# HISTORIC AND DESIGN REVIEW COMMISSION

October 16, 2019

**HDRC CASE NO:** 2019-411  
**ADDRESS:** 104 BEAUREGARD  
**LEGAL DESCRIPTION:** NCB 742 BLK 1 LOT NE 75.4 FT OF 1 & 2  
**ZONING:** RM-4,H  
**CITY COUNCIL DIST.:** 1  
**DISTRICT:** King William Historic District  
**APPLICANT:** Daniel Cruz/Design Coop  
**OWNER:** Marlo Montoya/MONTOYA MARLO R  
**TYPE OF WORK:** Construction of a 1-story rear accessory structure  
**APPLICATION RECEIVED:** September 23, 2019  
**60-DAY REVIEW:** November 22, 2019  
**CASE MANAGER:** Stephanie Phillips  
**REQUEST:**

1. Construct a 1-story rear accessory structure.
2. Modify the existing rear staircase on the primary structure to connect to the proposed primary structure.

PLAN: PROPOSED  
SCALE: 3/16" = 1'-0"

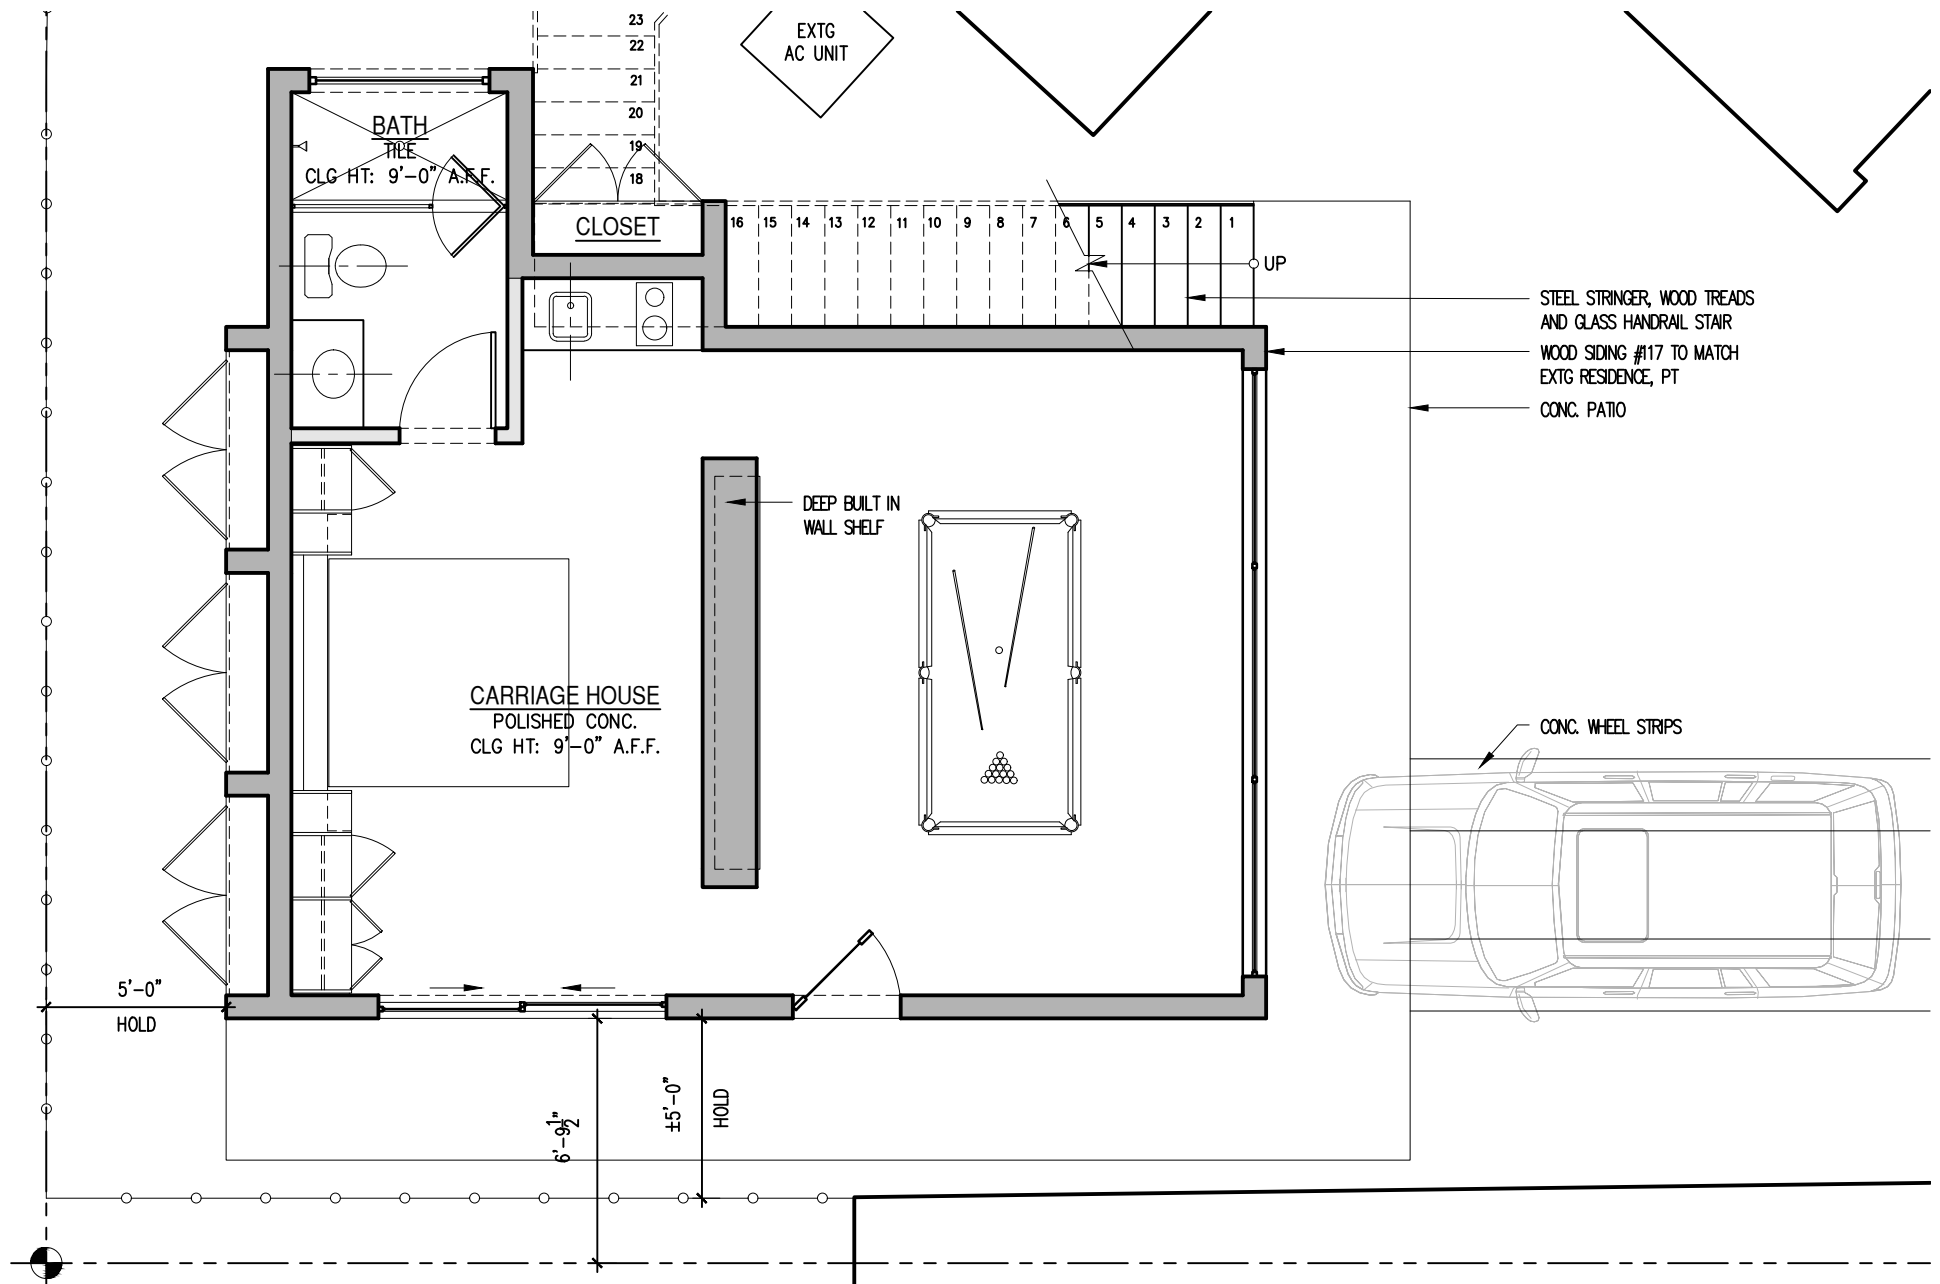
- d. FOOTPRINT – The applicant as proposed to construct a new 1-story accessory structure in the rear of the lot. While the dimensions are not indicated in the submitted documents, the footprint appears to be approximately 400 square feet. The Historic Design Guidelines for Additions stipulate that new garages and outbuildings should be less than 40% the size of the primary structure in plan. Staff finds the proposal generally consistent with the Guidelines.

ELEVATION: FRONT

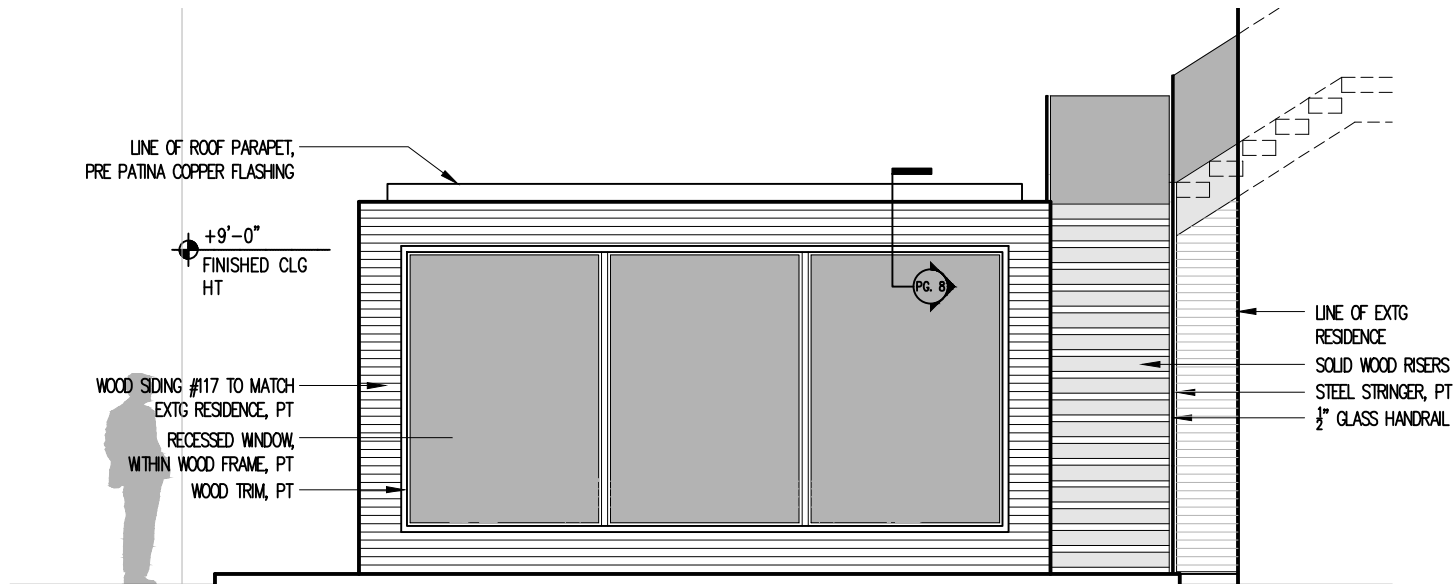
- h. **WINDOWS & DOORS** – The applicant has proposed 3 large picture windows on the front façade. The drawings indicate that windows will be inset within a wood frame. Additionally, a pair of wood sliding doors and a window wood door will be installed on the left façade; three pairs of solid wood doors will be installed on the rear façade; and a horizontal single lite window will be installed right façade. According to the Historic Design Guidelines, window and door openings should be designed to be similar to those found on historic garages or outbuildings in the district or on the principle historic structure in terms of their spacing and proportions. While staff finds the solid and sliding doors appropriate, the proposed window configurations are not consistent with existing precedents in the district or the existing primary historic structure. Staff does not find the proposal consistent with the Guidelines. Staff finds that the applicant should integrate window opening proportions that are more consistent with the Guidelines, the OHP Window Policy document, and the historic examples found in the King William Historic District.

- DRC supports steel stairs over wood, but acknowledges differentiation with glass rail.
- Flat roof structure references previous flat roof
- DRC emphasized breaking up 3 picture windows (4x8')
- DRC emphasized historic proportions if contemporary materials & forms proposed.
- DRC ~~decreasing~~ encourages more width on side elevation flanking large window detail; i.e. emphasize sitting detail in massing.

- i. That the applicant integrates window opening proportions that are more consistent with the Guidelines, the OHP Window Policy document, and the historic examples found in the King William Historic District as noted in finding h.
- ii. That the applicant install windows that include traditional dimensions and profiles, be recessed within the window frame, feature traditional materials or appearance and feature traditional trim and sill details as noted in findings f and h.
- iii. That the applicant integrates traditional roof forms and detailing as noted in finding g.
- iv. That the applicant proposes a simple wood and steel staircase with traditional balustrades and pickets as noted in finding k.

ELEVATION: LEFT

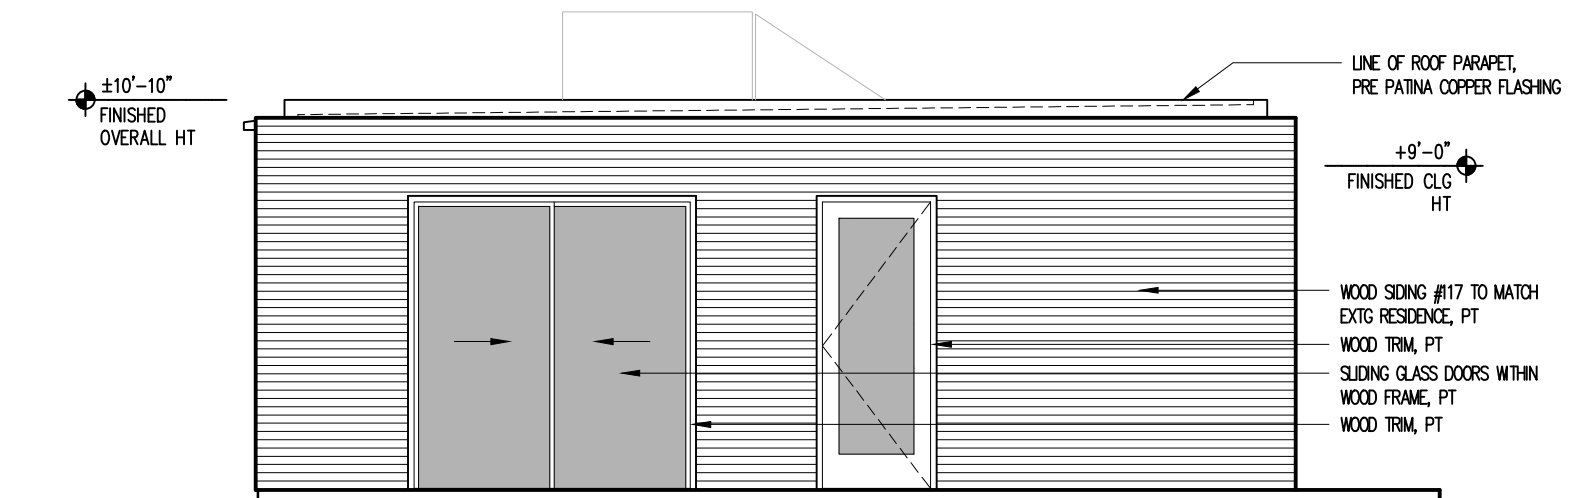
- k. **STAIRWAY MODIFICATIONS** – The applicant has proposed to remove the rear wooden stairway on the primary structure and construct a new steel stairway with wood treads that connects to the northwest façade of the proposed rear accessory structure. The staircase will feature glass on the sides in lieu of a traditional picket or balustrade detail. According to the Historic Design Guidelines, existing porch features should be preserved. If modification is necessary, new elements, such as stairs, should be simply designed and utilize similar materials to the historic structure. Staff finds that a simple steel staircase with balustrades would be more consistent with the Guidelines.

DETAIL: ROOF STRUCTURE  
SCALE: 1 1/2" = 1'-0"

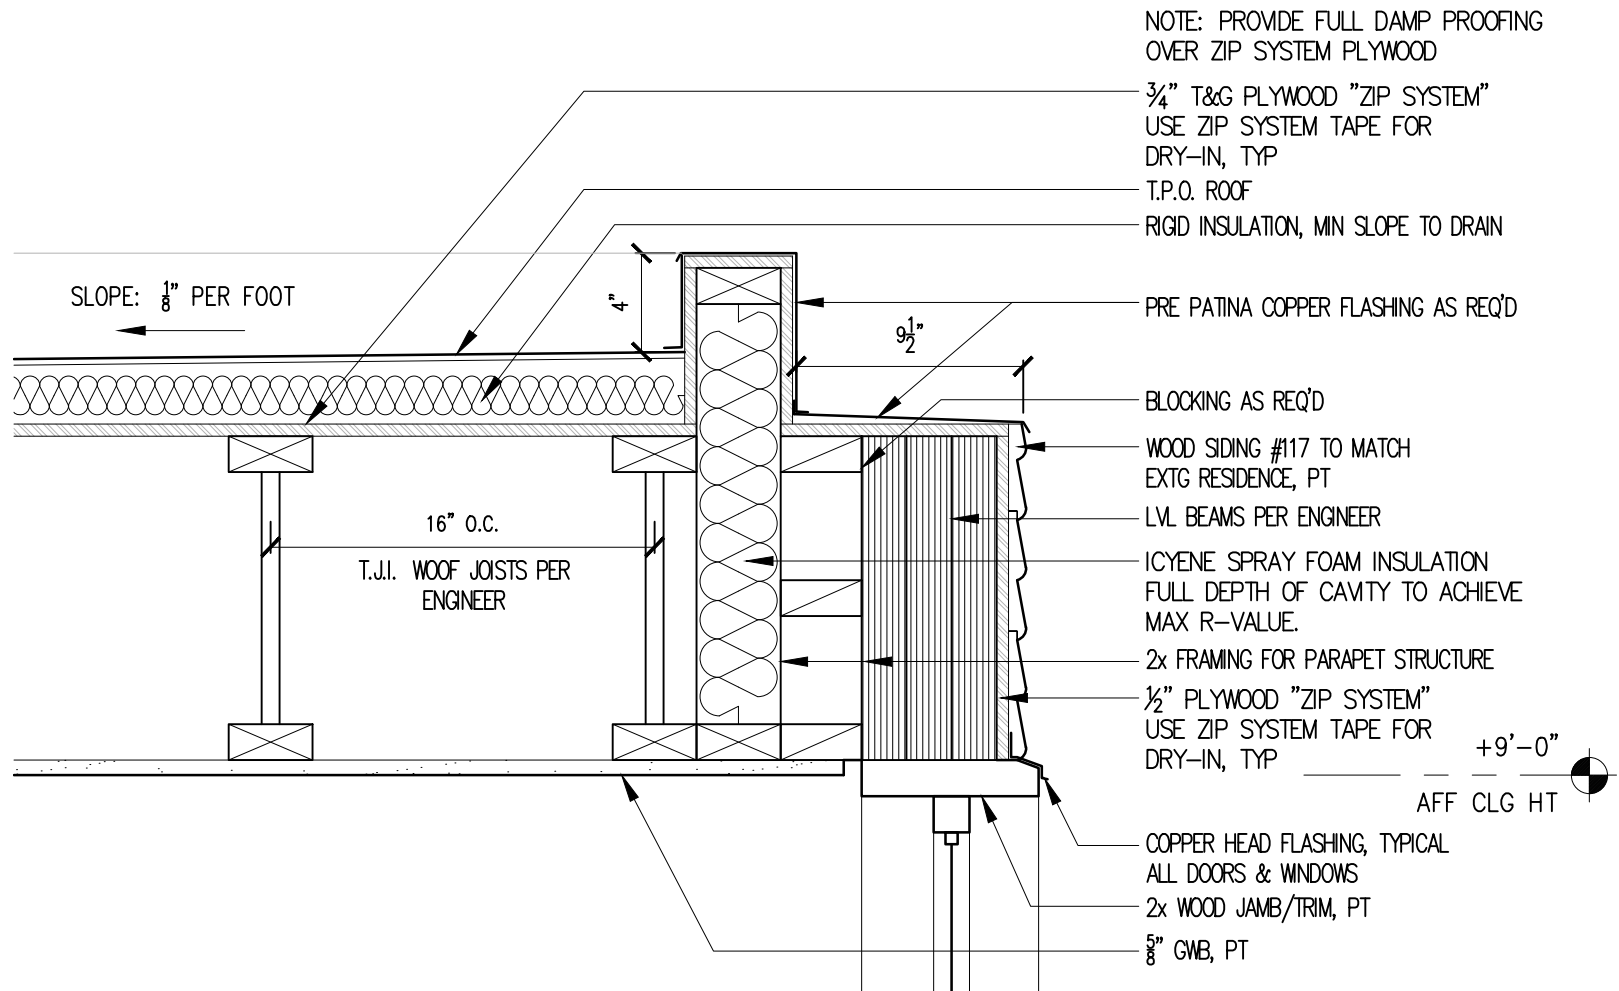
- g. **ROOF FORM** – The applicant has proposed a 1-story accessory structure with a multi-height flat roof. The lower portion of the structure will be approximately 10 feet and the tallest portion of the structure will measure approximately 10'-10" from the ground. Based on the submitted elevations, the parapet will be inset from the main façade of the structure and will be clad with a pre-patina copper flashing. The Guidelines stipulate that architectural details of new construction should keep with the predominant architectural style along the block face or within the district when one exists. Staff finds the general concept of a flat roof appropriate for the site, especially since the previous historic carriage house featured a flat roof with a slight slope, but does not find the structure as currently designed consistent with traditional roof forms and configurations.
